Subject: ELECTRIC POWER RESEARCH INSTITUTE – SUBMITTAL OF RESPONSES TO THE US NRC’s REQUEST FOR ADDITIONAL INFORMATION (JANUARY 2025) ON EPRI’S TECHNICAL REPORT 3002025288, “ENHANCED RISK-INFORMED CATEGORIZATION METHODOLOGY FOR PRESSURE BOUNDARY COMPONENTS”.

**EPRI REPORT 3002025288, "ENHANCED RISK-INFORMED CATEGORIZATION
METHODOLOGY FOR PRESSURE BOUNDARY COMPONENTS"**

REQUESTS FOR ADDITIONAL INFORMATION (RAIS)

Figure 1
Categorization process overview [2]

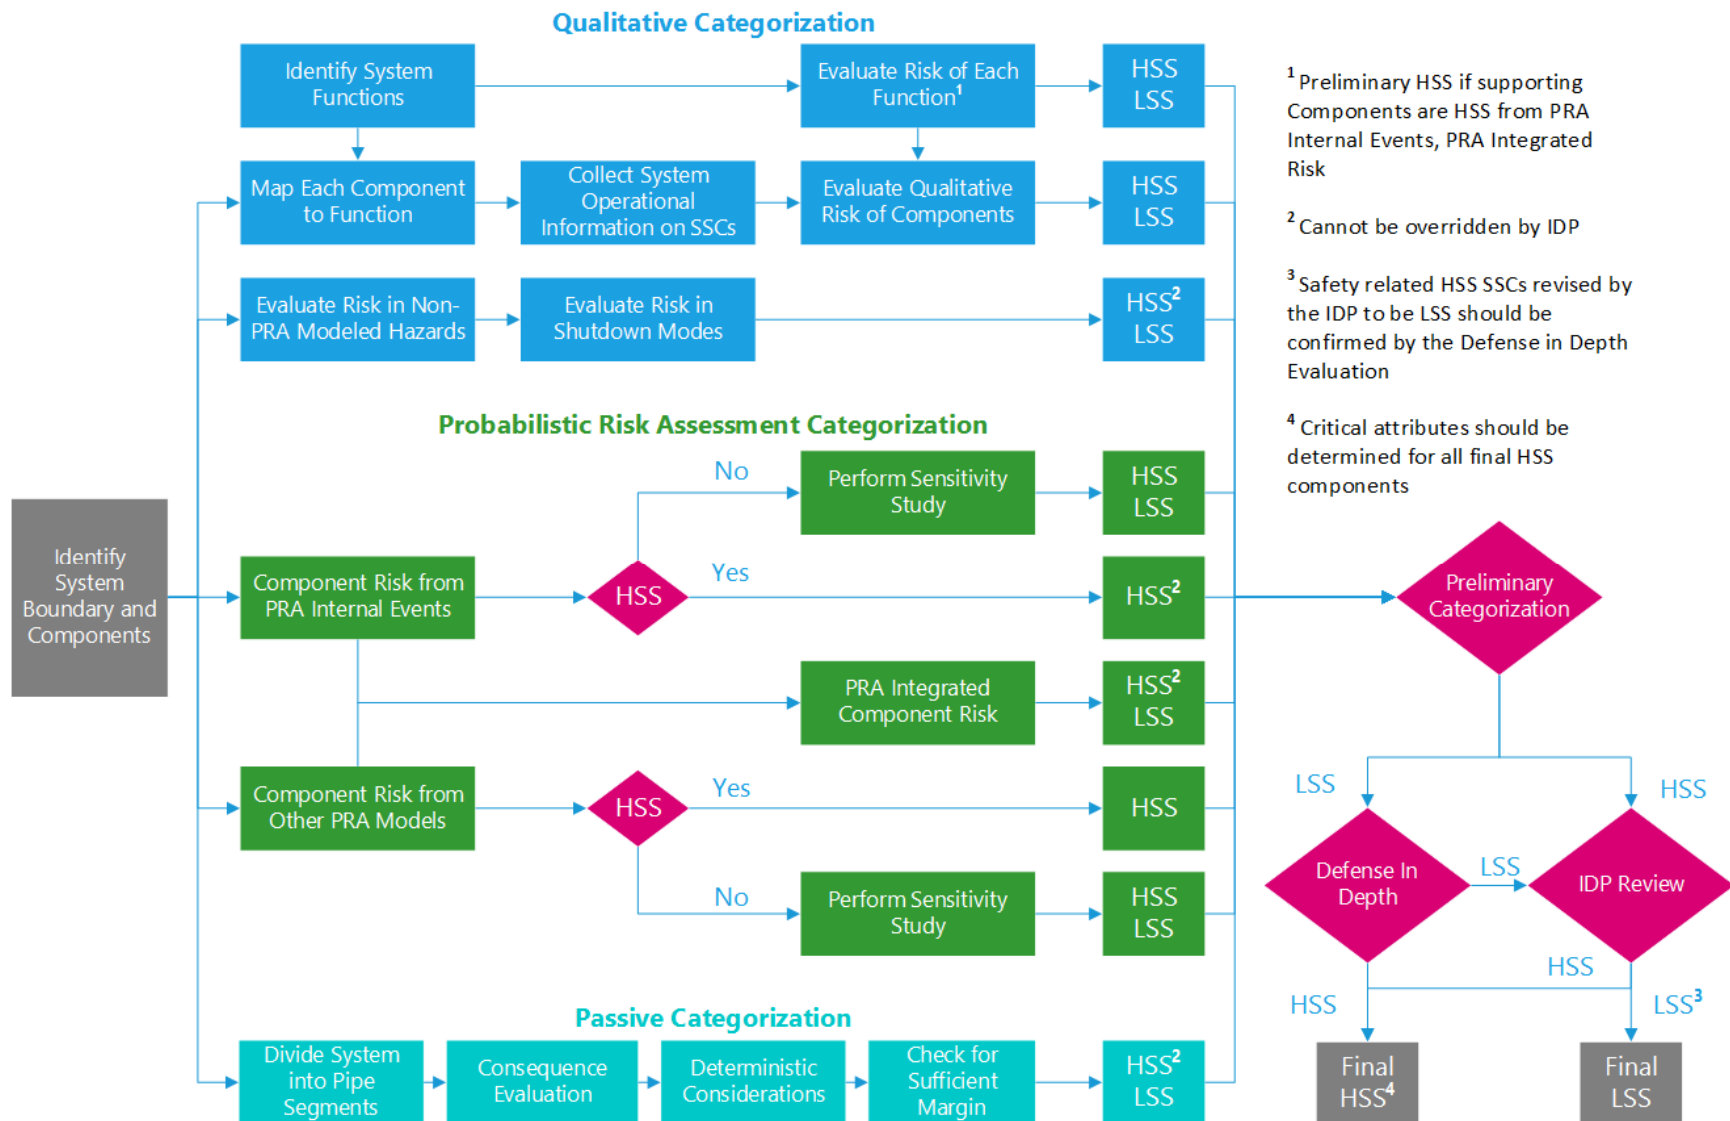
Figure 1 of the TR, “Categorization process overview”, depicts the overall 50.69 categorization process as intended to be implemented, and shows that the passive categorization is performed in parallel to the other aspects of the categorization, such as considerations based on PRA and other qualitative consideration. All these aspects are considered for the preliminary categorization step, per the guidance in Nuclear Energy Institute (NEI) 00-04 Section 7. The guidance in NEI 00-04 Section 7 states that SSCs that support multiple functions should be assigned the highest risk significant of any function that the SSC, or part thereof, supports. Finally, the inputs from the preliminary categorization are provided to the integrated decision-making panel (IDP). Table 1 of the TR states that the IDP cannot change categorization from HSS to LSS for passive components.

- b. As indicated in Figure 1 of the TR, the passive categorization is one aspect of the systematic and integrated categorization process outlined in NEI 00-04. Describe further how the passive categorization will be executed part of the overall integrated categorization process. Describe how the guidance in NEI 00-04 Section 7 for preliminary categorization will be implemented for passive components. How will all aspects of the categorization process be considered for the preliminary categorization of SSCs (both active and passive) that will be provided to the IDP?

EPRI Response to RAI 2b:

Exercising the process in TR 3002025288 would allow for pre-determined criteria to be applied upfront to the pressure-retaining function as described in Section 4.2. When using TR 3002025288, the existing integrated categorization process (e.g., NEI 00-04) would remain in place for components with active functions (i.e., no change in the active function or the integrated approach).

From a practical implementation perspective, the passive/pressure boundary categorization will be presented to the IDP as a complete package (e.g., the full plant evaluation of the pressure retention function, that is all safety related and non-safety related pressure boundary components) for final categorization. After this categorization, as new systems are categorized – each system results will include the active and passive functions for IDP review and concurrence. The active functions will continue to be categorized consistent with guidance in NEI 00-04 as currently performed. This sequence assures the IDP can assess the entire pressure boundary system at the beginning (IDP panel specific to categorization based on TR 3002025288) and also assures that each subsequent system characterization (that is active and pressure boundary functions) also reflect the entire NEI 00-04 process.

Figure 3
Flowchart of Phases 1-3 of the enhanced passive methodology

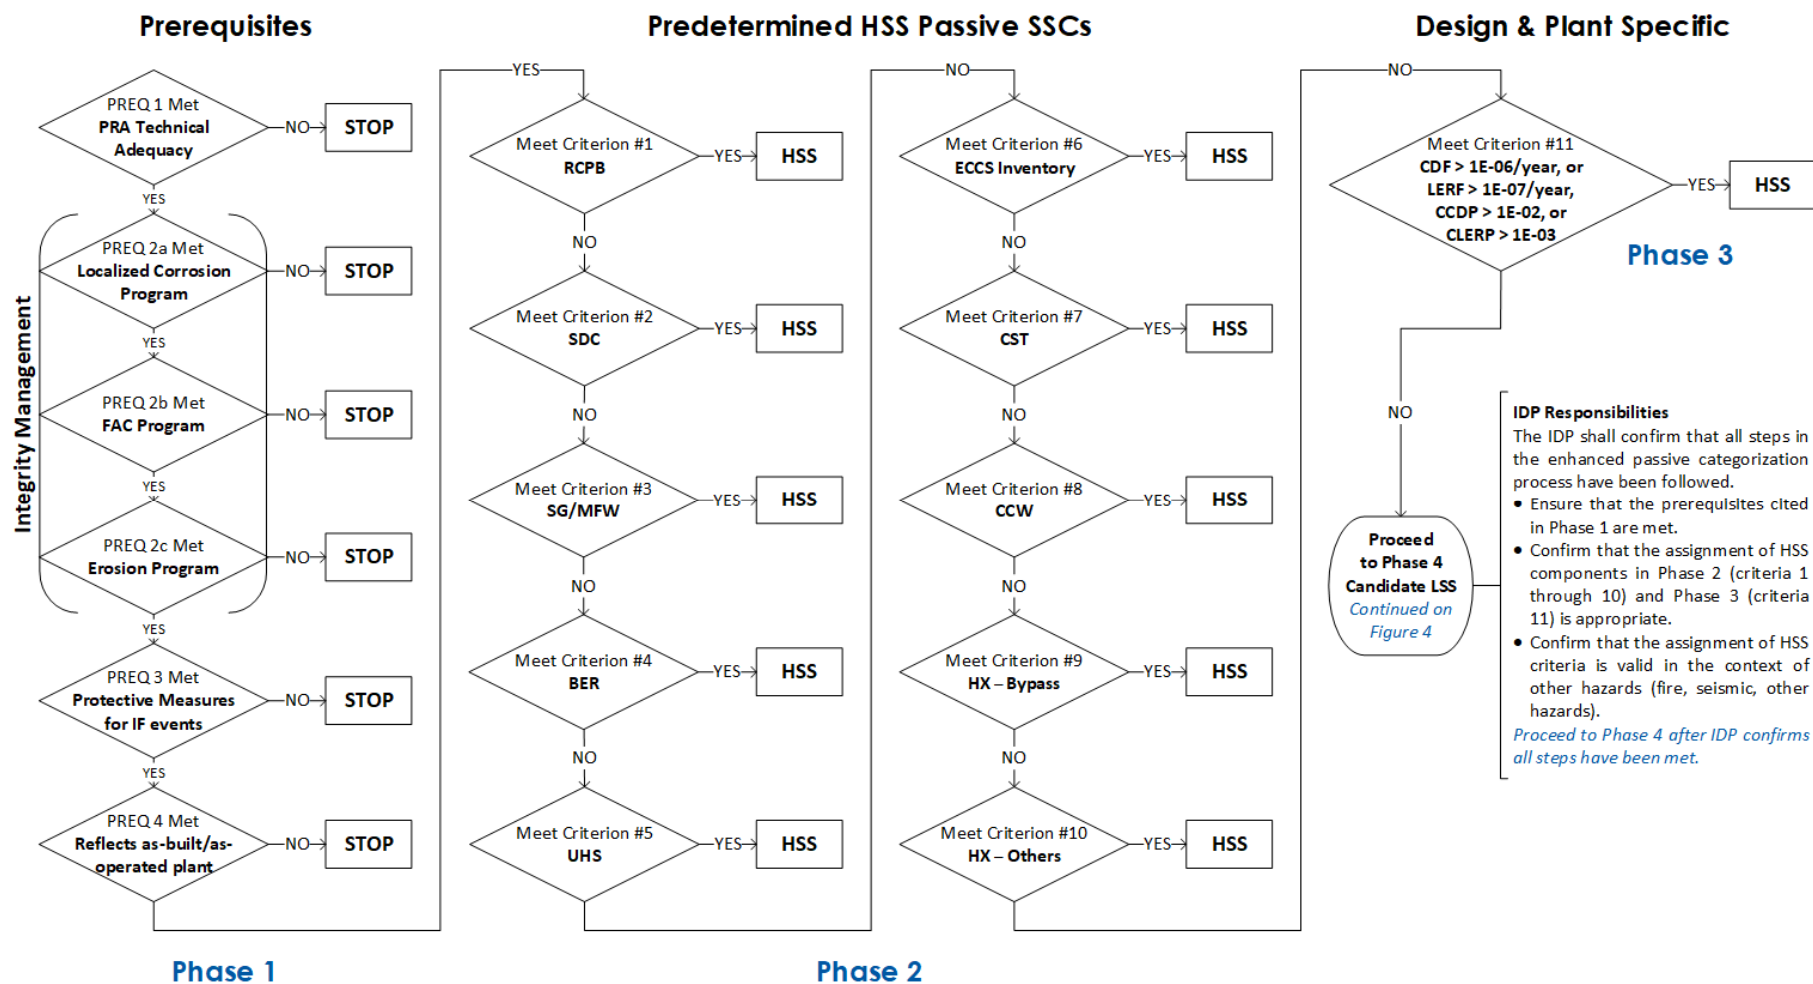
- a. Criteria 11-13 are the only criteria in the methodology that involves a direct use of the licensee’s PRA model-of-record. From Figure 3, “CCDP versus CDF threshold” and Figure 4, “CLERP versus LERF threshold”, it appears that each of the three criteria have “hard” risk thresholds. Explain how uncertainty is taken into account within the use of these thresholds to categorize a passive pressure-retaining component. Also, explain how the potential cumulative impact of changes is addressed.

All pressure boundary failures that are plant initiating events are modeled in the PRA, as required per the NRC-endorsed ASME/ANS PRA Standard. As discussed in Section 4.1.1 Prerequisite 1: PRA Technical Adequacy, the licensee must have a plant-specific internal events and internal flooding PRA of sufficient quality (peer reviewed against the ASME/ANS PRA Standard) to support the LAR approval process. Pressure boundary failures, such as pipe ruptures, are evaluated quantitatively per criterion 11 of the enhanced methodology. Regarding uncertainty within the use of the thresholds to categorize a passive pressure-retaining component, [NUREG-1855](#) and the two companion EPRI reports ([1016737](#) and [1026511](#)) provides the methodology for assessing and addressing uncertainties in PRA models used in risk-informed decision making.

In implementing TR 3002025288, the list of assumptions and sources of uncertainty needs to be reviewed to identify those which would be significant for the risk-informed categorization of the pressure boundary. If the plant-specific PRA model uses non-conservative treatments, or uses methods not commonly accepted, the underlying assumption or source of uncertainty would need to be reviewed to determine its impact on the risk-informed categorization of the pressure boundary. Only those assumptions or sources of uncertainty that could significantly impact the categorization risk calculations (i.e., could change a categorization outcome) would be considered key for this application. An example is shown in Table 1.
